Inland Empire Energy Center

(01-AFC-17)

Amendment No. 1

(GE H Technology and Additional Laydown Area)

FIGURE 2-10
CONSTRUCTION GRADING & DRAINAGE
PLAN

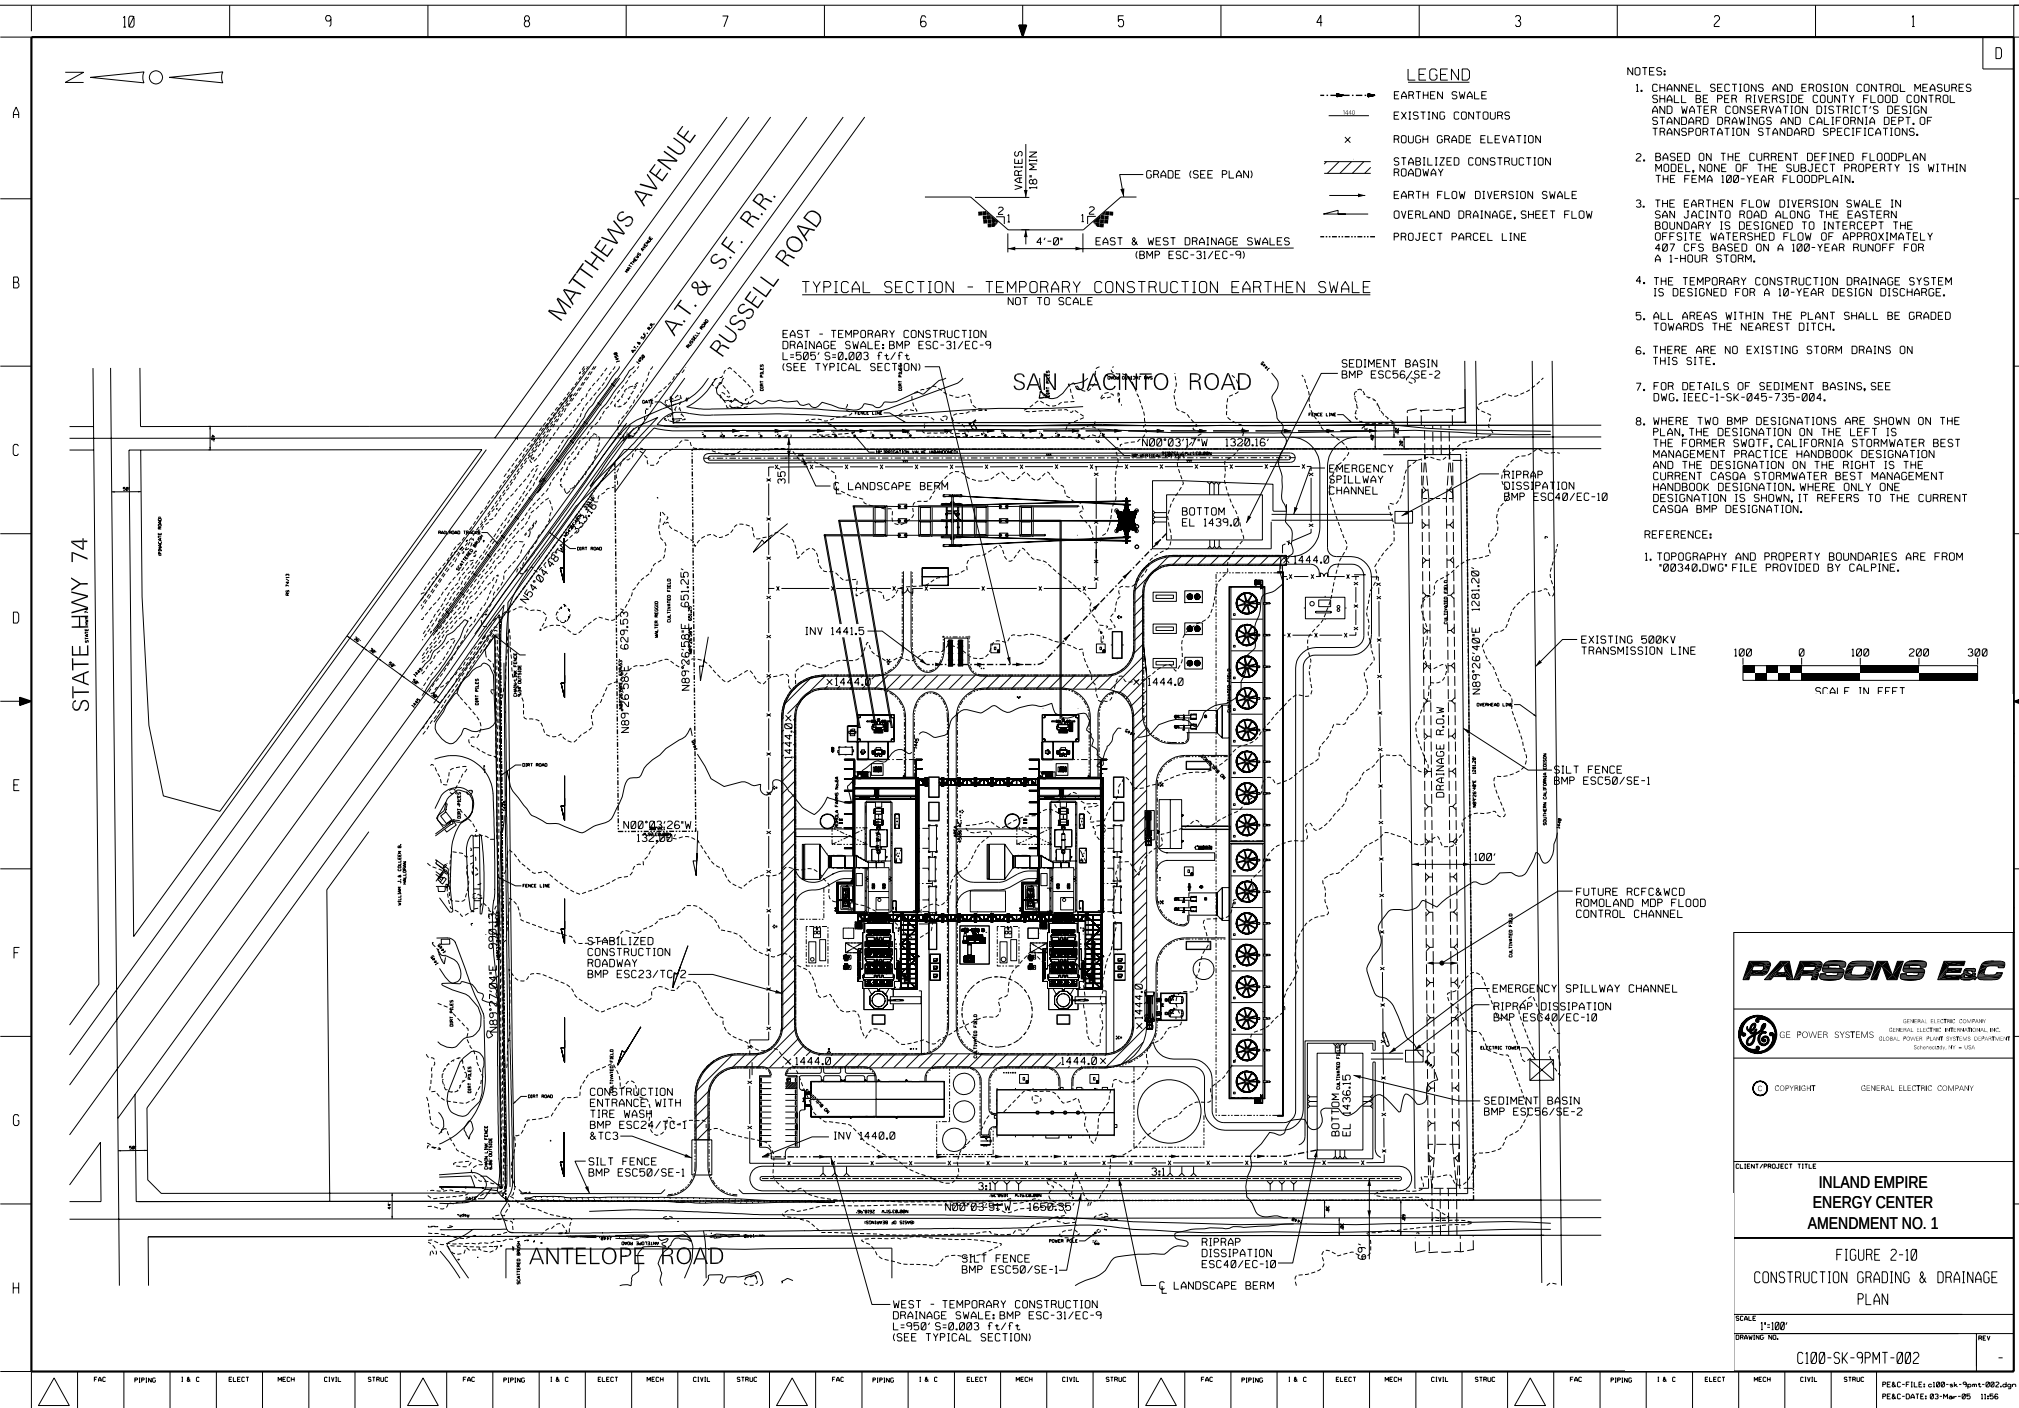
Figure 2-10 shows the grading and drainage plan for the IEEC during the construction phase. Off-site storm water runoff will be diverted around the project site similar to that shown for the operating facility. For control of on-site runoff, north-south running earthen swales will be constructed on the east and west sides of the site to collect storm water and divert it to the sediment basins located at the south end of the site.

Figure 2-10 shows the grading and drainage plan for the construction phase with storm water BMPs and their locations identified. This plan is similar to that proposed in the AFC, except that two storm water detention ponds are proposed instead of a single pond.

Hessler Associates, Inc. Consultants in Engineering Acoustics Drawing #: IE-Rev-M-3		Description:	Prepared for:
	Inland Empire Energy Center Amendment No. 1		FIGURE 3.7-1 EXPECTED NOISE EMISSION CONTOURS FROM ATTENUATED ENERGY CENTER	GE Energy
				Date: October 13, 2004

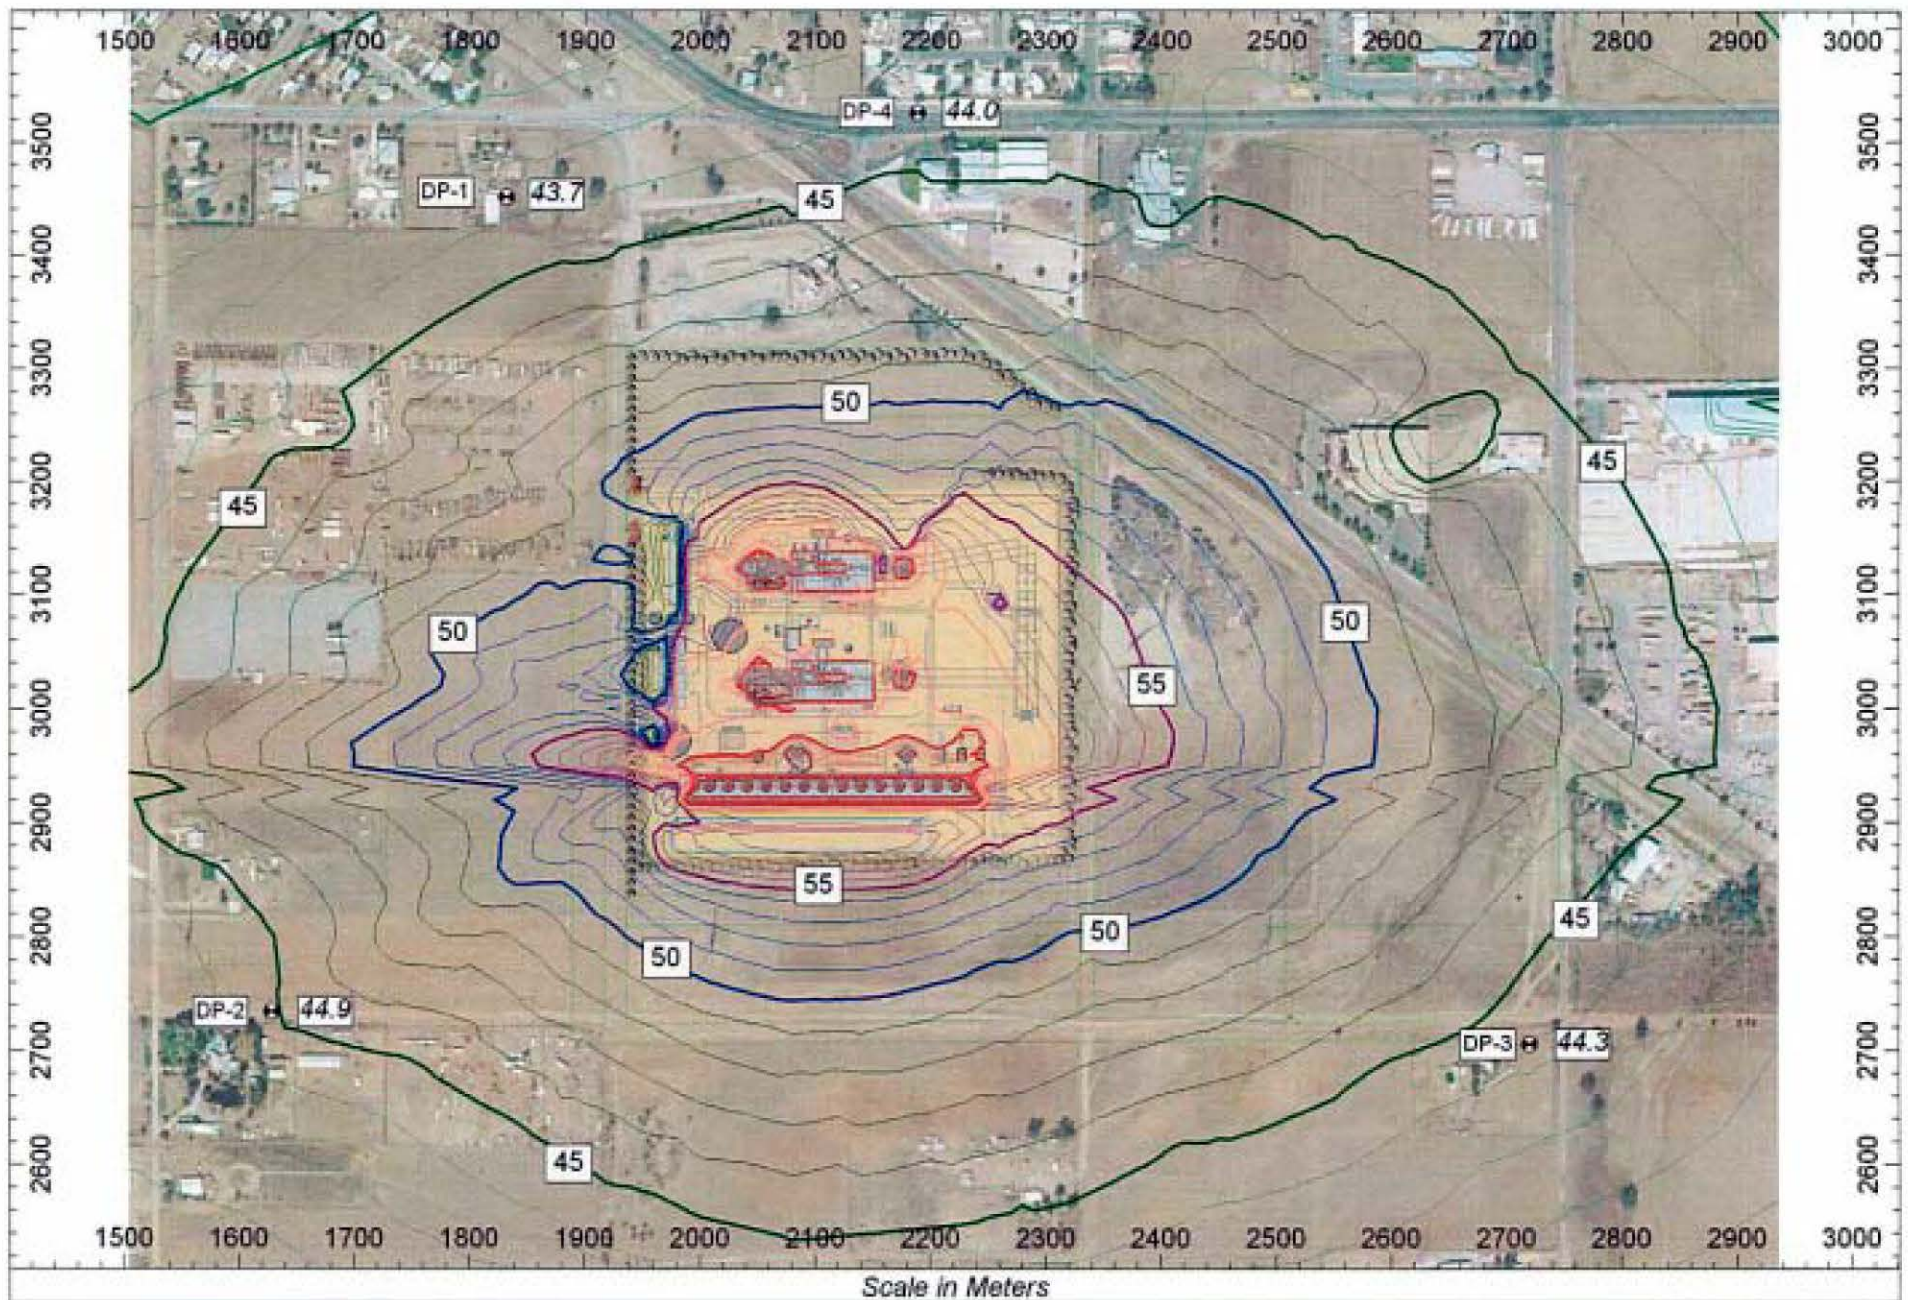
Figure 3.7-1 shows the plant operation noise contours generated by the noise modeling program as well as the locations of the four design points (DPs), representing the closest sensitive receptors. Table 3.7-1 compares the expected energy center noise levels with the design goal of 45 dBA, at each of the four locations. As shown in Table 3.7-1, the IEEC is expected to produce noise levels that are equal to or below the design goal.

Plant noise contours depicted in Figure 3.7-1 are based on the following noise attenuation measures:
